Review of the Proposed Balustrades for the new Access Ramp into Bay 4

TKDArchitects
Tanner Kibble Denton

ASN BUILDING BAY 4-5

A. PROPOSED RAMP – AS DETAILED AND DOCUMENTED – VIEW 1

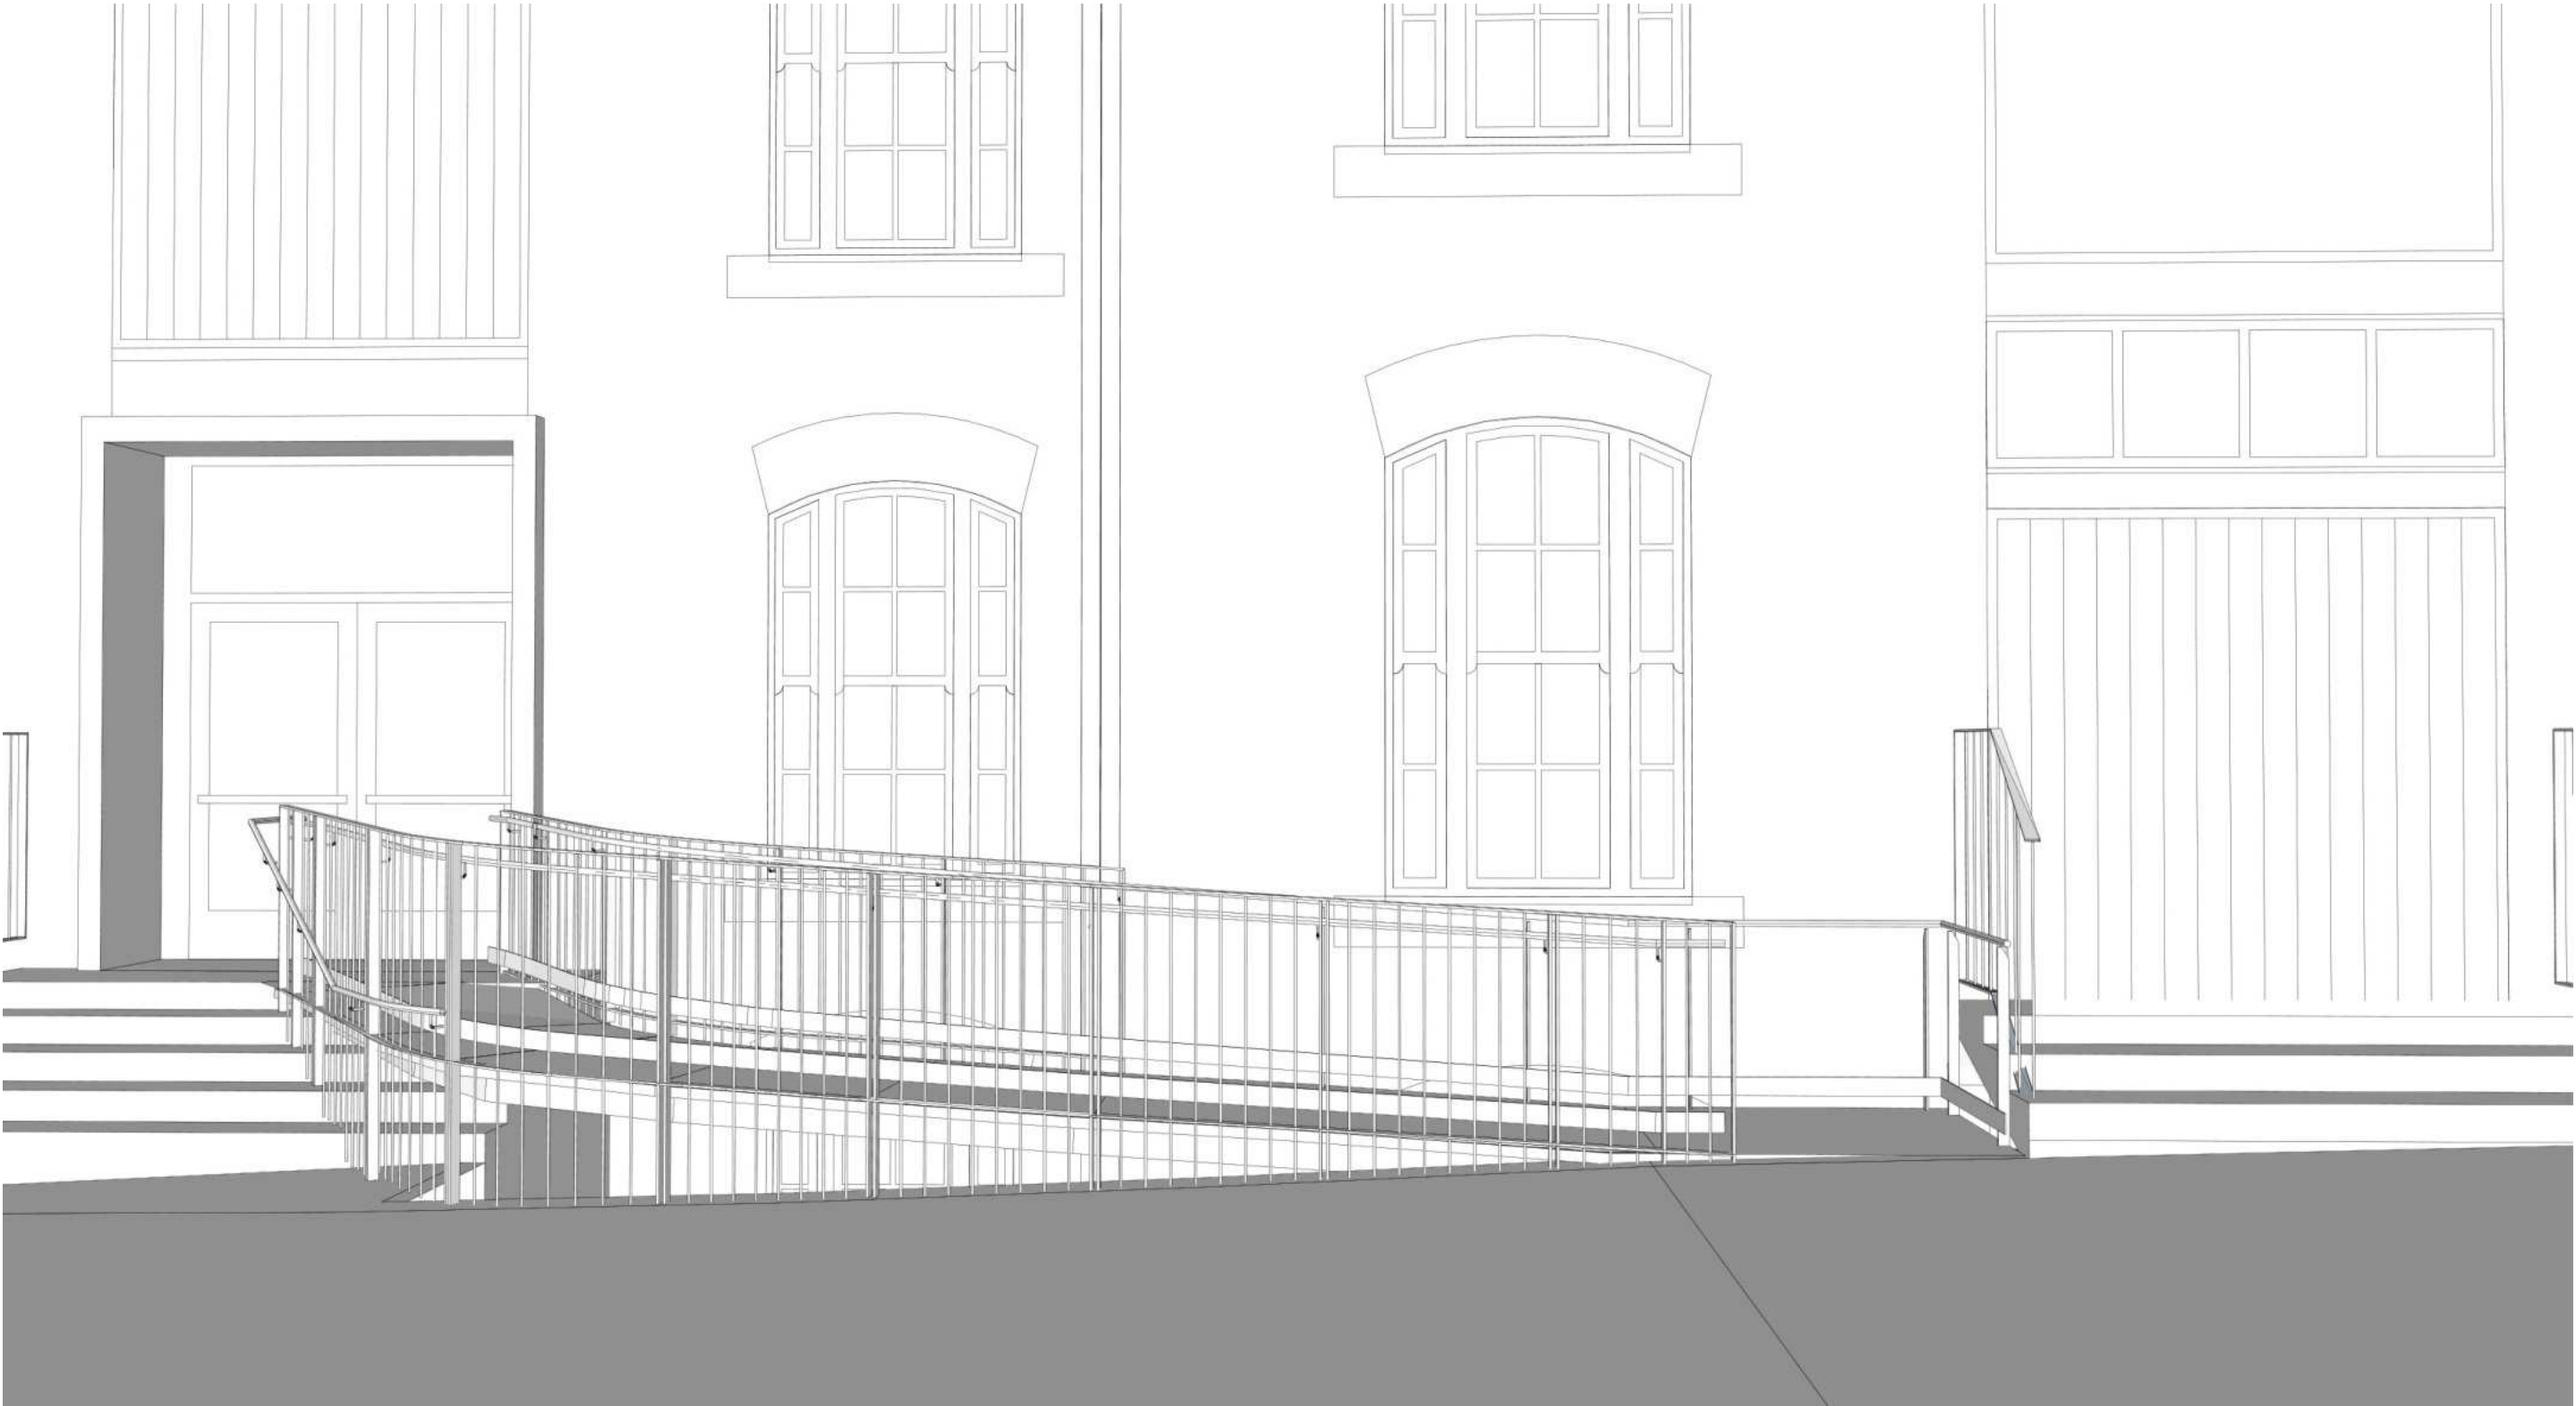
Existing concrete kerb and balustrade is removed to allow for the ramp to be built to the boundary (to ensure the ramp does not touch the façade).

New balustrade rods match existing and extend down to above the pavement to infill the void below the structure and allowing for views to the façade below.

Posts incorporate LED strip lighting to illuminate the ramp avoiding façade lighting.

B. RESPONSE TO SHFA HERITAGE – NEW BALUSTRADE IN ALIGNMENT WITH EXISTING – VIEW 2

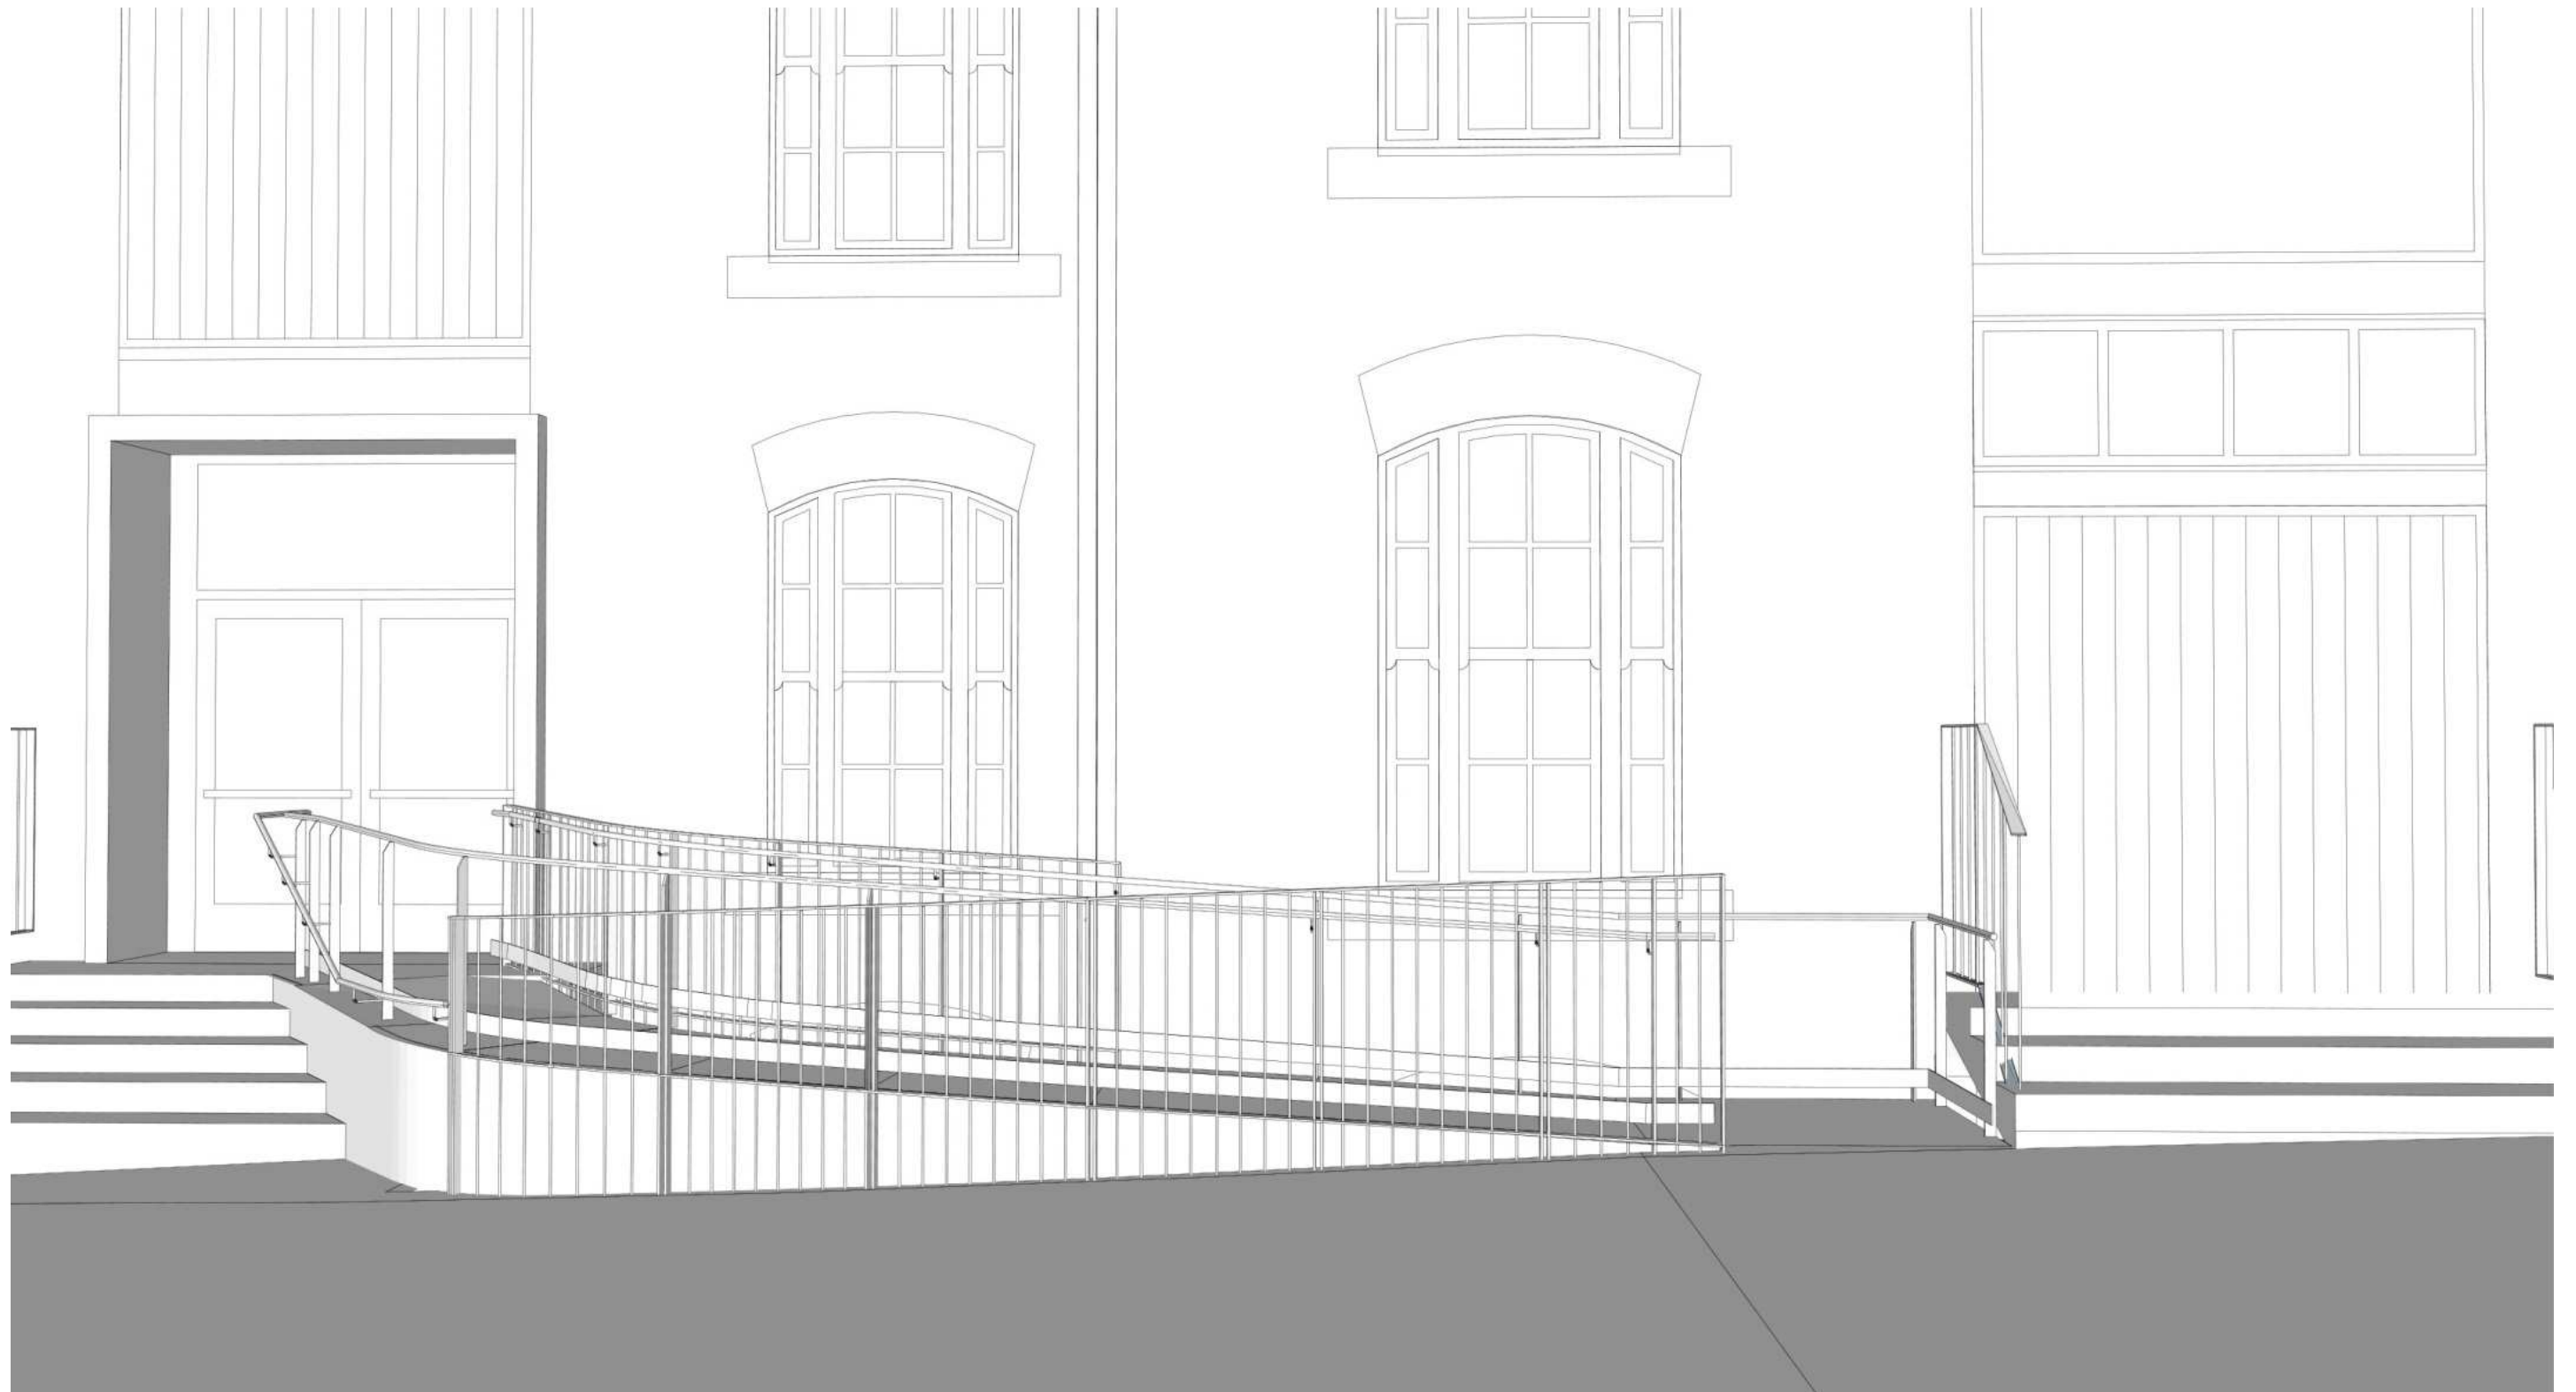
Existing concrete kerb and balustrade removed. Existing cannot be retained due their position.

New balustrade to the rake of the existing in a new alignment and incorporating lighting for ramp.

Option B2 – Solid infill below ramp to above the step treads and pavement to infill the open void.

B. RESPONSE TO SHFA HERITAGE – NEW BALUSTRADE IN ALIGNMENT WITH EXISTING – VIEW 3

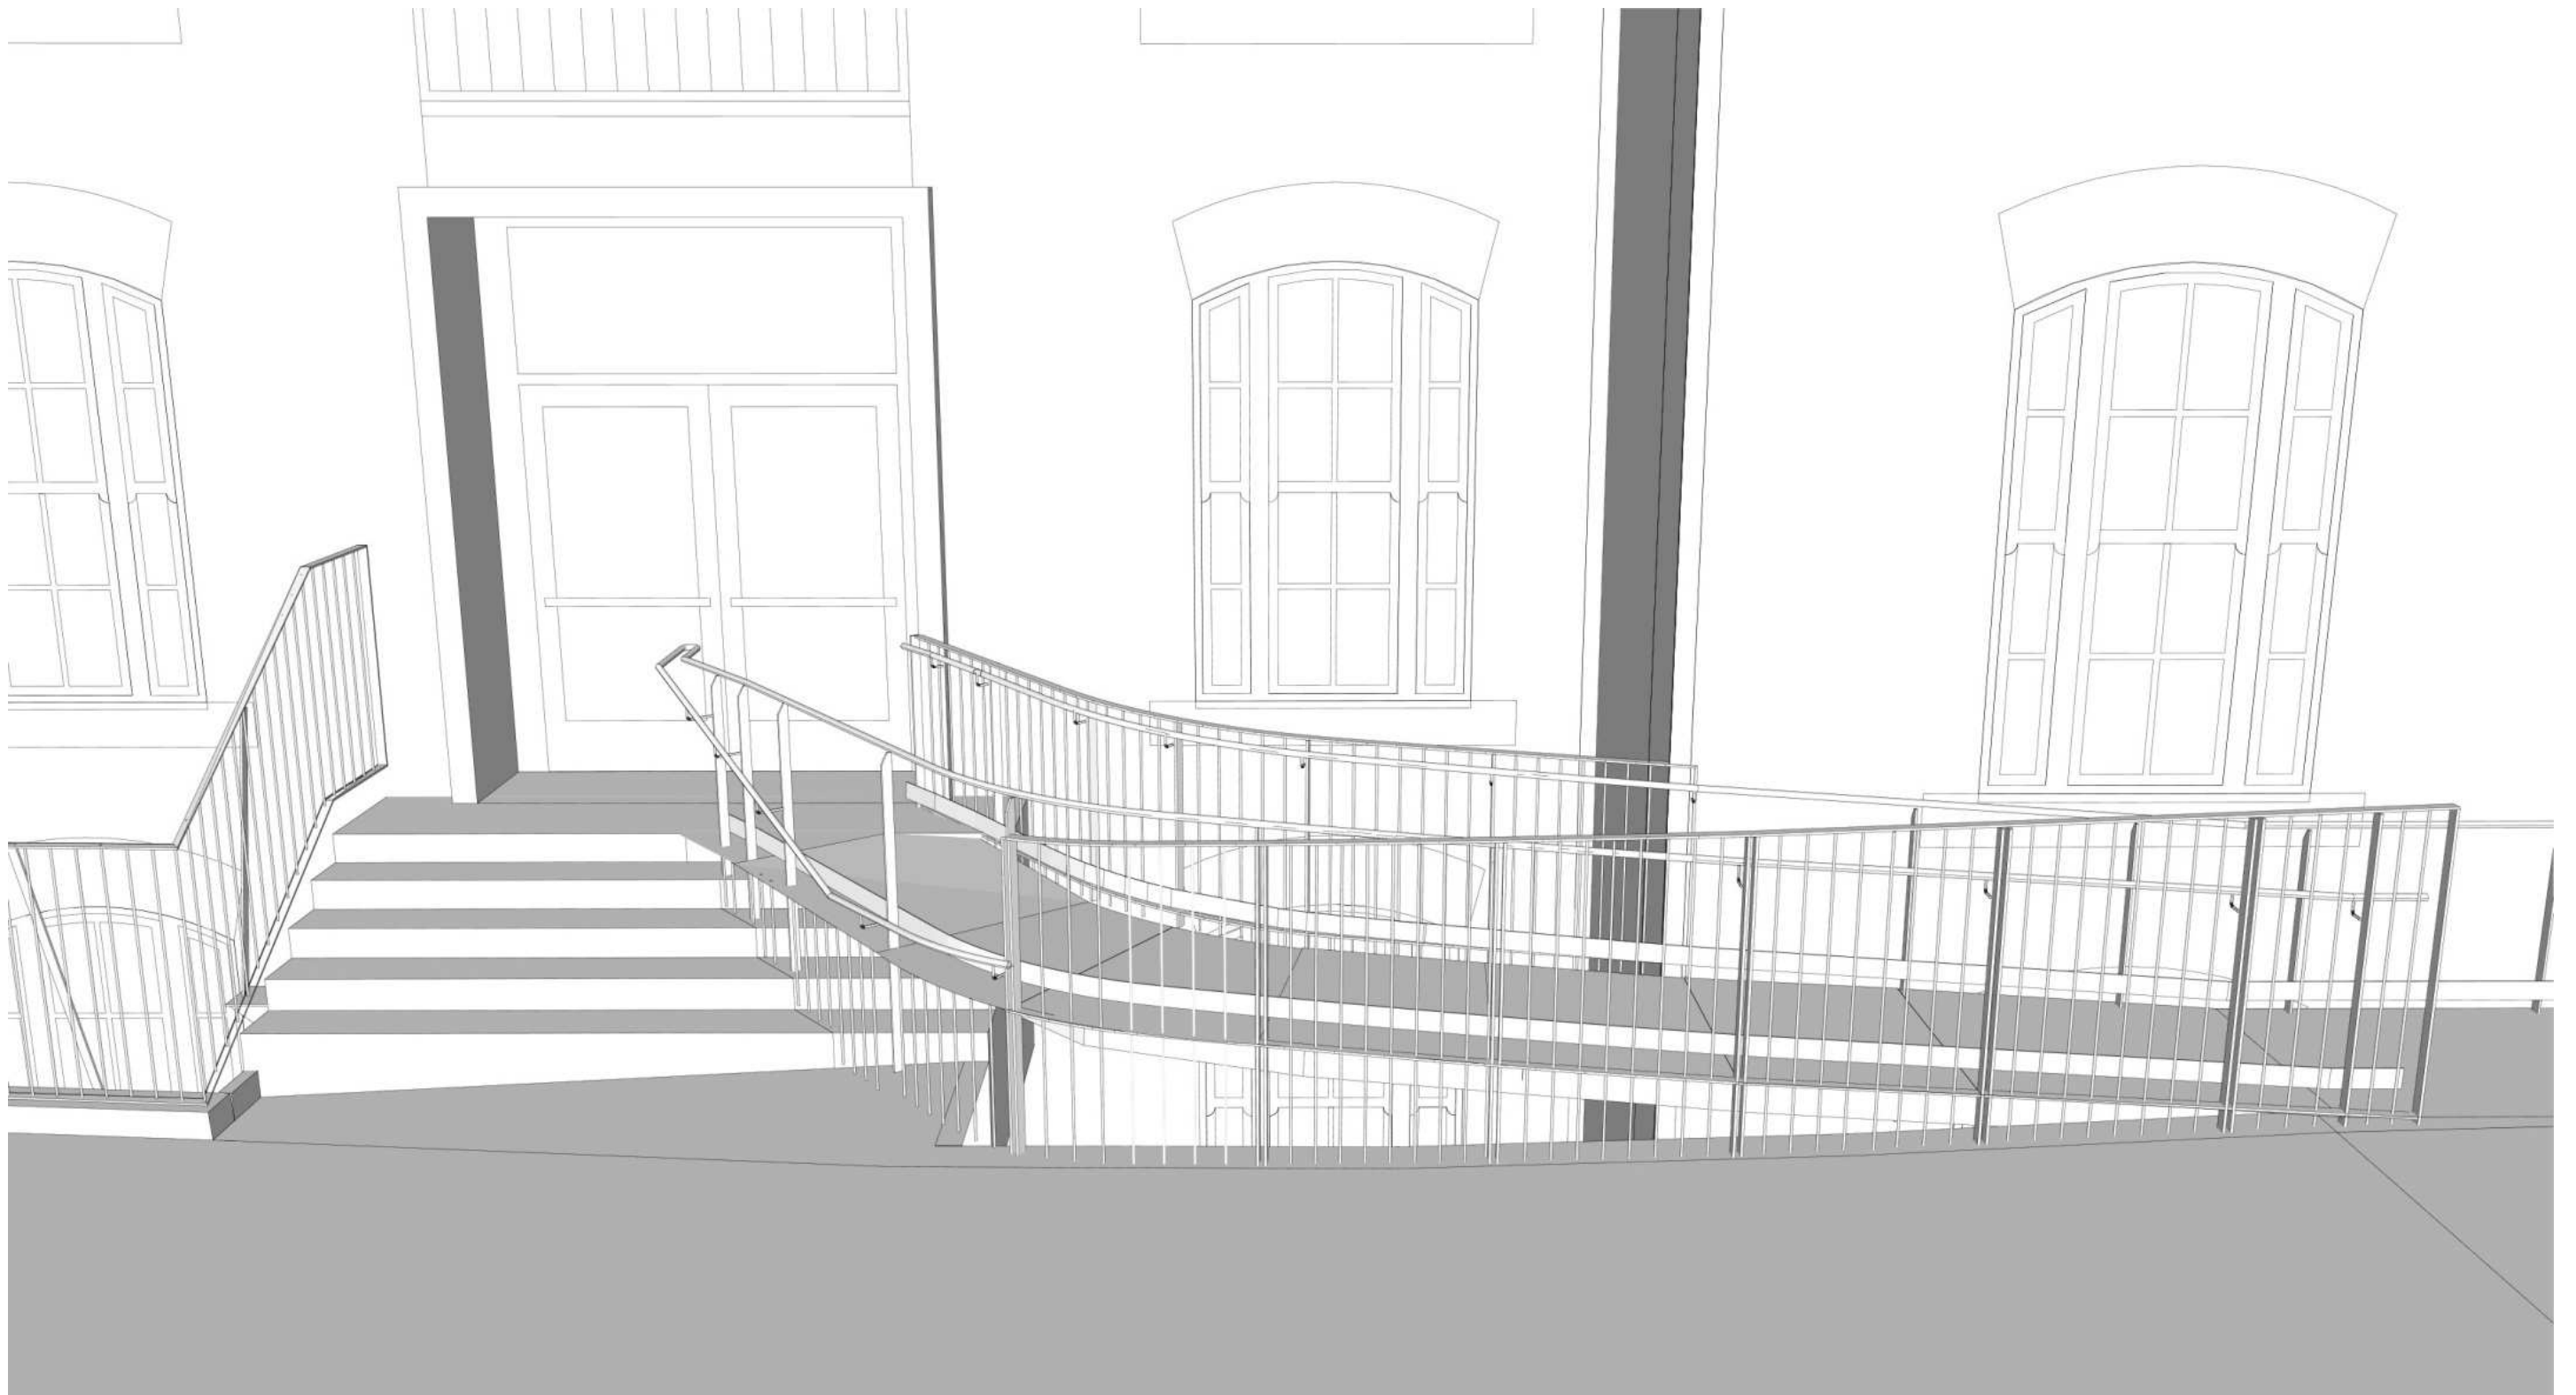
Option B2 – Closer View. Views of the façade are obscured by the ramp in this proposal.
